Summary of Expert Review Comments and Responses:  
*Draft Inventory of U.S. Greenhouse Gas Emissions and Sinks: 1990-2019*

July 2021  
U.S. Environmental Protection Agency  
Office of Atmospheric Programs  
Washington, D.C.

Responses to Comments Received during the Expert Review Period on  
the *Inventory of U.S. Greenhouse Gas Emissions and Sinks: 1990-2019*

**Figure A.** Estimation of emission factor using linear regression of United States plant data (adapted from (Ahn et al. 2010)).

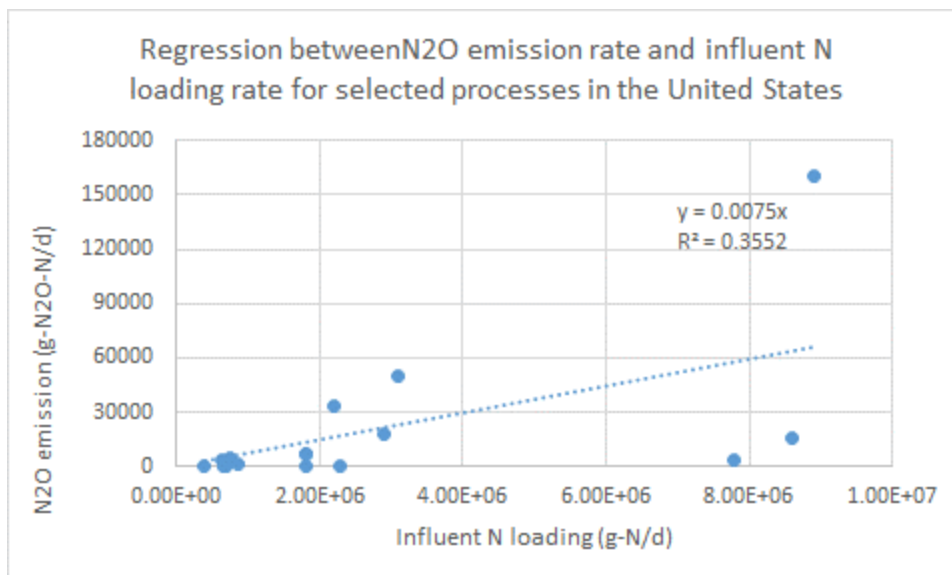
Furthermore, the value in the IPCC document for this emission factor (or strictly speaking, emission fraction) is an average calculated from different studies including the most extensive one to date conducted in the United States (Ahn et al. 2010). If we focus just on the plants in the United States, then the values for this emission fraction for mainstream centralized wastewater treatment systems including both biological nitrogen removal (BNR) and non-BNR processes are in the range  $0.0048 \pm 0.0059$  kg N<sub>2</sub>O-N/kg influent N (adapted from (Ahn et al. 2010)). Alternatively, if we follow the same approach as that of the IPCC (linear regression of emission against influent N loading), then the estimated emission fraction is 0.0075 kg N<sub>2</sub>O-N/kg influent N with a R<sup>2</sup> value of 0.3552 and a p-value of 0.0015 (data used for regression presented in Table A on pages 2-3 of this document and also presented in Figure A on page 3 of this document). Notwithstanding that these values are averages or estimated using linear regression, these are still more reasonable (and lower) relative to the IPCC value, which is skewed towards the very high end of the range observed in the United States (as identified in the primary study (Ahn et al. 2010)). It would be useful to include a comparison of the emissions calculated using the previous two-emission factor approach (for BNR and non-BNR systems and normalized to population equivalents) and this newly proposed approach.

It might be useful to also consider a more mechanistic approach to estimate emissions based on the actual performance of the specific wastewater treatment process if it might not be possible to measure such emissions. N<sub>2</sub>O emissions are a function of the concentrations of the different N-species (such as ammonia, nitrite and nitrate) as well as operating dissolved oxygen concentration in the wastewater treatment processes themselves (Tables II and III in (Ahn et al. 2010)). Where possible and feasible, if such operating data are available in conjunction with measured N<sub>2</sub>O emissions values, plant-specific models could be developed the use of which could provide a more efficient option to estimate emissions.

I focus on the US plants and the US study primarily because the data were obtained using an EPA approved methodology. We don't know how reliable the estimated or measured emissions are from the other studies referenced in the 2019 IPCC study.

**Response:** *With regard to the error in emissions factor noted by the commenter, see page 7-43, EPA has fixed the error, which was a typo in the text (i.e., the correct value was used in the calculation of emissions). With regard to the comment on the increased accuracy of using a U.S.-specific emission factor instead of an IPCC default factor and further accuracy of using one emission factor for biological nitrogen removal systems and a second for systems other than those with biological nitrogen removal, EPA agrees. However, it is not clear if there are sufficient data to support this change. On page 7-52, we have included this in the Planned Improvements discussion for Chapter 7.3 Wastewater Treatment and Discharge in the Inventory report as follows so that we may explore for the next Inventory cycle: Review whether sufficient data exist to develop US-specific N<sub>2</sub>O emission factors for domestic wastewater treatment systems, including whether emissions should be differentiated for systems that incorporate biological nutrient removal operations.*
